Access Compliance Report

Public Rights-of-Way

Intersection ID: 44418	Main Street: TRAVIS_GULCH_DR	Cross Street: ARDREY_KELL_RD	Location: NW
ADA ID: A01D071E3E55	Ramp Type: PerpDiag	Initial Pass/Fail: Pass	Overall Compliance: No
		Severity Score: 0.25

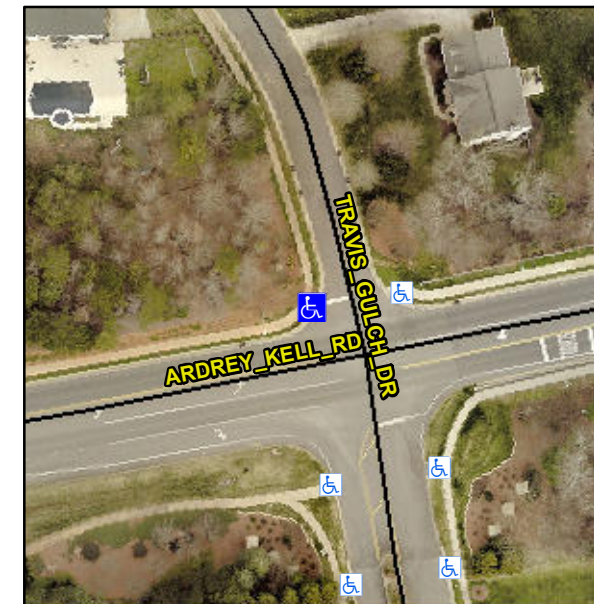
Not Found, R304.5.3, R304.2.1, R304.2.2-Perp, R304.3.2-Para

Compliance	Description	Data	Compliance	Description	Data
N/A	Ramp Length (in)	43.5	Yes	Ramp Slope (%)	5.8
Yes	Ramp Width (in)	48.0	No	Ramp XSlope (%)	3.0
N/A	Flare Type LT	Sloped	N/A	Flare Type RT	N/A
N/A	Flare Slope LT (%)	6.8	Yes	Flare Slope RT (%)	2.1
N/A	Flare Traversable LT?	Yes	N/A	Flare Traversable RT?	Yes
Yes	Landing Length (in)	48.0	Yes	DWS Provided?	Yes
No	Landing Width (in)	47.0	Yes	DWS Contrast?	Yes
No	Landing Slope (%)	3.5	Yes	DWS Length (in)	24.0
No	Landing X Slope (%)	2.9	Yes	DWS Full Width?	Yes
N/A	Landing Curb? (Y/N)	No	Yes	DWS Offset (in)	1.5
N/A	Shared Landing?	No			
Yes	Gutter Ponding?	No	Yes	Gutter Slope (%)	1.1
Yes	Gutter Lip Ht (in)	0.0	No	Gutter X Slope (%)	2.2
N/A	Painted X Walk1?	No	N/A	Painted X Walk2?	No
	X Walk 1 Direction	To S		X Walk 2 Direction	To E
N/A	X Walk 1 Width (in)	N/A	N/A	X Walk 2 Width (in)	N/A
	X Walk 1 Slope (%)	0.8		X Walk 2 Slope (%)	0.4
	X Walk 1 X Slope (%)	0.1		X Walk 2 X Slope (%)	2.8

Remove & Replace Curb Ramp With Two New Directional Ramps or Equivalent. Remove & Replace Gutter.
